22-014AFDP – MOBILITY HUB – DUBLIN RECREATION CENTER

Summary

Review and approval for the construction of a mobility hub located on a 56.81-acre site.

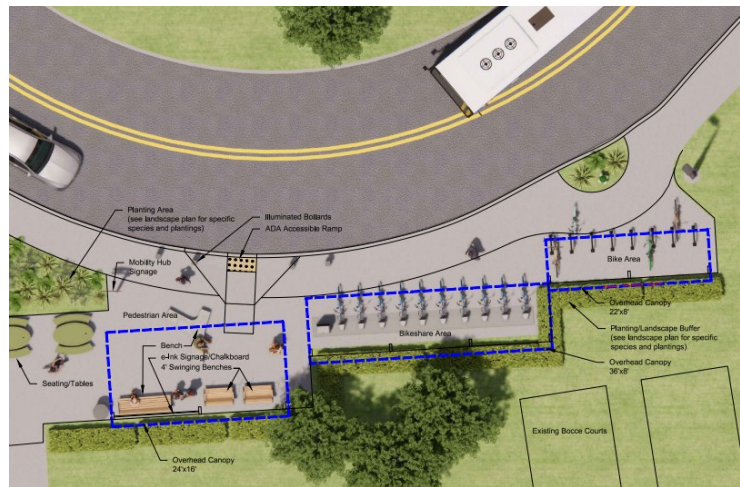
Staff is concerned regarding some of the plant species chosen including the Dark Green Arborvitae and the Apple Serviceberry. The Dark Green Arborvitae tends to grow very tall. Staff recommends substituting Taxus in shaded areas and Mr. Bowling Bowl Arborvitae in sunny areas. Staff recommends Sweetbay Magnolia or Royal Raindrops Crabapple in place of the proposed Serviceberry's. Lastly, Staff recommends that the applicant continue to work with Staff to finalize the landscape plan.
